Access Compliance Report

Public Rights-of-Way

(Curb Ramps)

Intersection ID: 48770	Main Street: TURNING_WHEEL_DR	Cross Street: KNOTHOLE_LN	Location: NW
ADA ID: 3FE0A4B68E9D	Ramp Type: PerpDiag	Initial Pass/Fail: Fail	Overall Compliance: No
Severity Score: 8.75			
Codes/Mitigation Info/Possible Solution		Field Measurements/Component Compliance

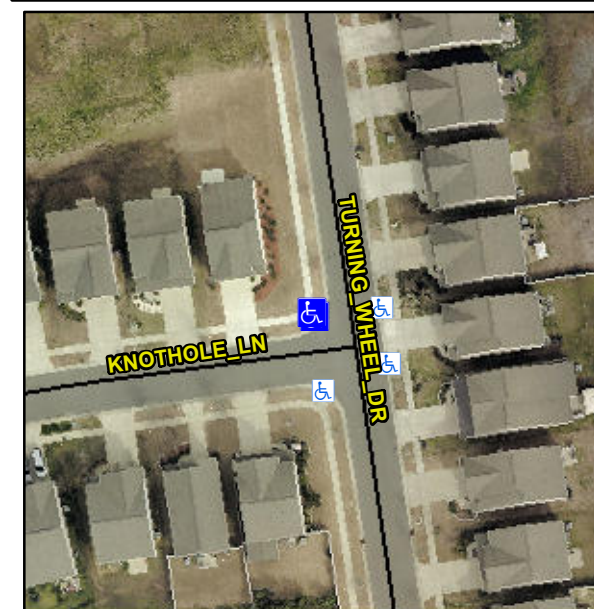
Remove & Replace Curb Ramp With Two New Directional Ramps or Equivalent.

R304.5.1
